# SERVICE BULLETIN

ENGINE - POWER PLANT - EEC AND IGNITION SUPPLY HARNESS, CLIPPING POINT - MODIFICATION  
OF - CATEGORY CODE 4 - MOD.ENG-71-0029

V2500-ENG-71-0029

Location of Clipping Point 0864  
Fig.1

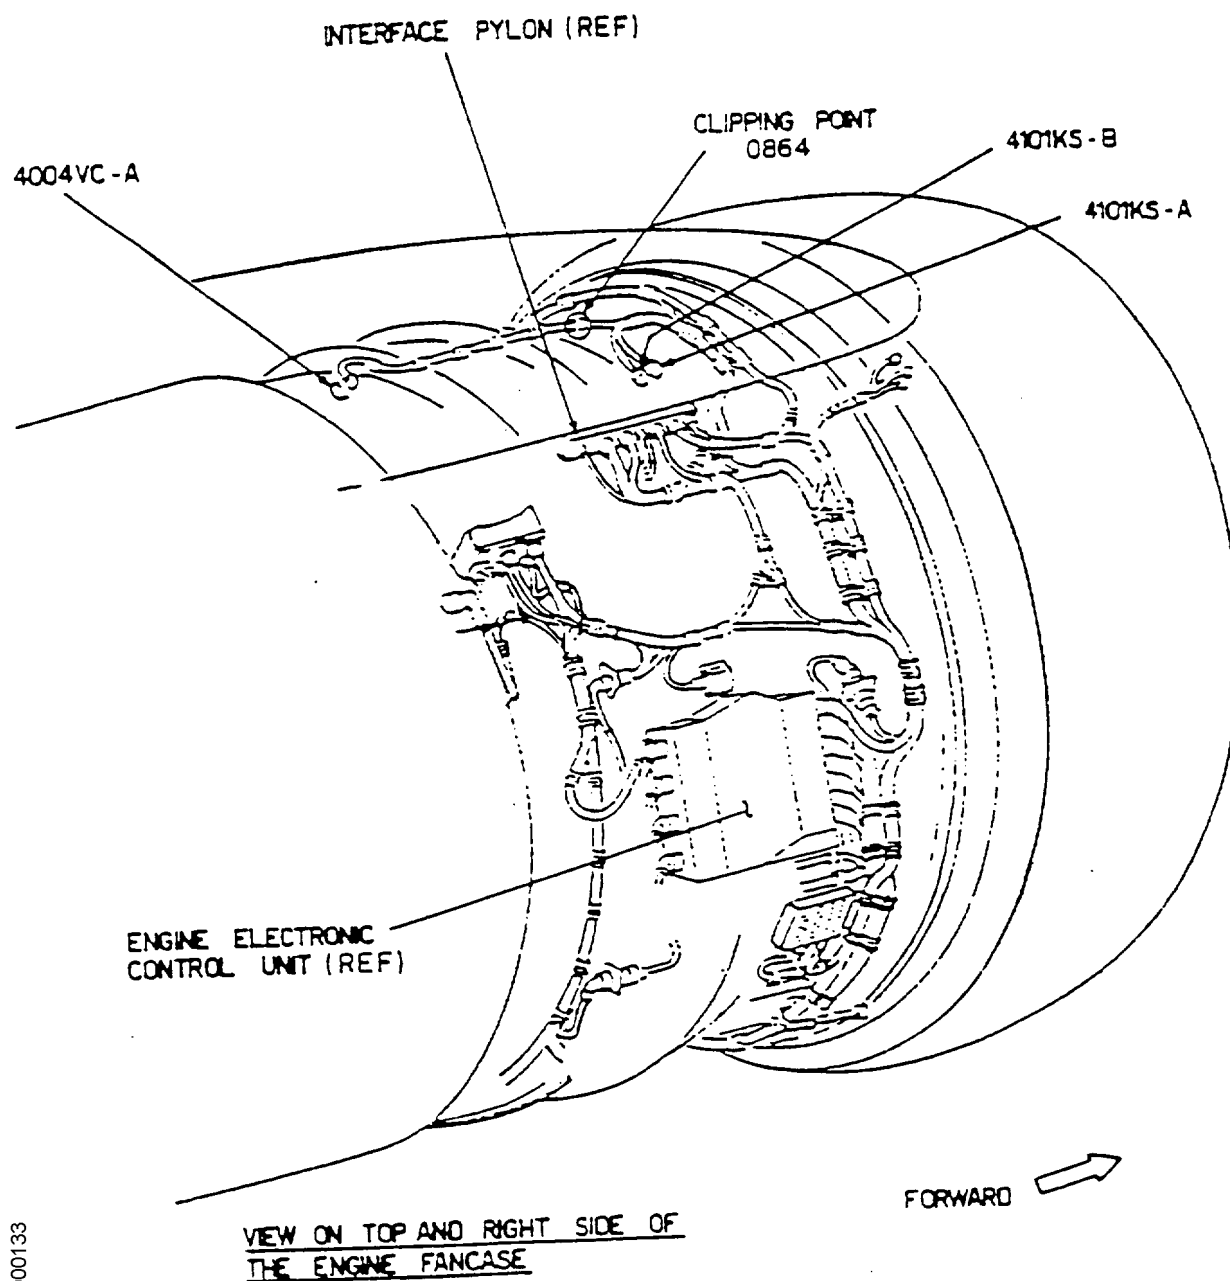
- (1) Open right hand fan cowl door as specified in the V2500 Aircraft Maintenance Manual, Task 71-13-00-010-010.
- (2) Find the 0864 clipping point on the engine fancase. (Refer to Figure 1.)

Clipping Point 0864  
Fig.2

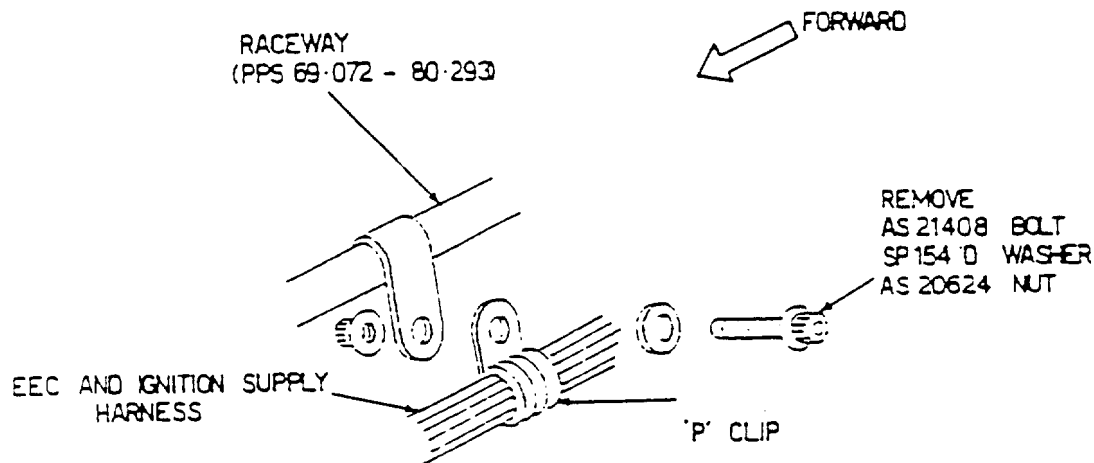
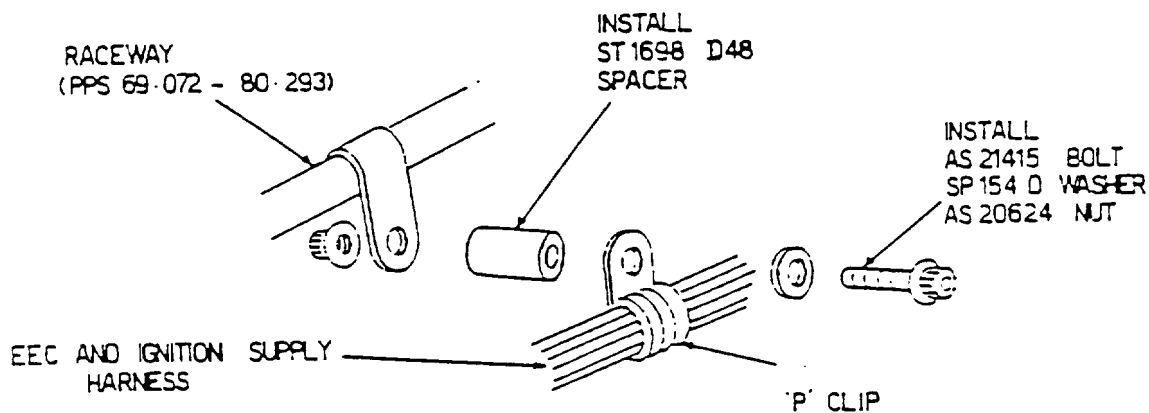
A spacer and longer bolt are installed at clipping point 0864 on the engine fan case. This modification will increase the clearance between the EEC and ignition supply harness and the engine flange.

- (1) Remove the AS21408 bolt, the SP154-D washer, and the AS20624 nut which attach the 'P' clip to the raceway. Discard the bolt. (Refer to Figure 2.)
- (2) Assemble the clipping point to the raceway as shown in the after configuration of Figure 2. Install the ST1698D48 spacer and attach the 'P' clip to the raceway with an AS21415 bolt, a SP154-D washer, and an AS20624 nut.
- (3) Torque the AS20624 nut to 40 lb-in. (4.52 N.m) as specified in the V2500 Aircraft Maintenance Manual, Task 70-23-11-911-010.
